Intersection ID: 10040791	Main Street: W_W_T_HARRIS_BV	Cross Street: N/A	Location:	NE
ADA ID: A3454FEAE495	Ramp Type: BlendTrans1	Initial Pass/Fail: Fail	Overall Compliance: No	Severity Score: 1.25

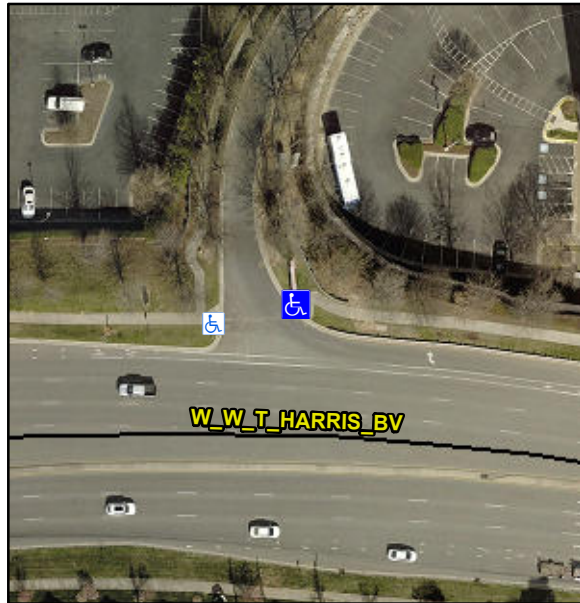
CURB LIP 1.0

Not Found, R304.5.3, R304.4.1

Compliance	Description	Data	Compliance	Description	Data
N/A	Ramp Length (in)	96.0	No	BlendTrans Slope (%)	5.5
Yes	Ramp Width (in)	48.0	No	BlendTrans XSlope (%)	4.5
N/A	Flare Type LT	N/A	N/A	Flare Type RT	N/A
N/A	Flare Slope LT (%)	N/A	N/A	Flare Slope RT (%)	N/A
N/A	Flare Traversable LT?	N/A	N/A	Flare Traversable RT?	N/A
N/A	Landing Length (in)	N/A	N/A	DWS Provided?	N/A
N/A	Landing Width (in)	N/A	N/A	DWS Contrast?	N/A
N/A	Landing Slope (%)	N/A	N/A	DWS Length (in)	N/A
N/A	Landing X Slope (%)	N/A	N/A	DWS Full Width?	N/A
N/A	Landing Curb? (Y/N)	N/A	N/A	DWS Offset (in)	N/A
N/A	Shared Landing?	N/A			
N/A	Gutter Ponding?	N/A	N/A	Gutter Slope (%)	N/A
N/A	Gutter Lip Ht (in)	N/A	N/A	Gutter X Slope (%)	N/A
N/A	Painted X Walk1?	No	N/A	Painted X Walk2?	No
	X Walk 1 Direction	To W		X Walk 2 Direction	To S
	X Walk 1 Width (in)	N/A		X Walk 2 Width (in)	N/A
	X Walk 1 Slope (%)	2.5		X Walk 2 Slope (%)	1.6
	X Walk 1 X Slope (%)	0.5		X Walk 2 X Slope (%)	0.8

N/A	Ramp inside XWalk1?	N/A	N/A	Ramp inside XWalk2?	N/A
	Road Slope (%)	0.1		Clear Space?	N/A
	Road X Slope (%)	1.0	N/A	Clear Space to XWalk (in)	N/A
N/A	Any Obstructions?	N/A	N/A	Storm Grate/Utility Hazard?	N/A
	Obstruction Type			Storm Grate/Utility Type	
		N/A			N/A
			Yes	Surface Condition? (G/P)	Good
			No	Curb Slope (%)	7.8

Remove & Replace Curb Ramp With Two New Directional Ramps or Equivalent.
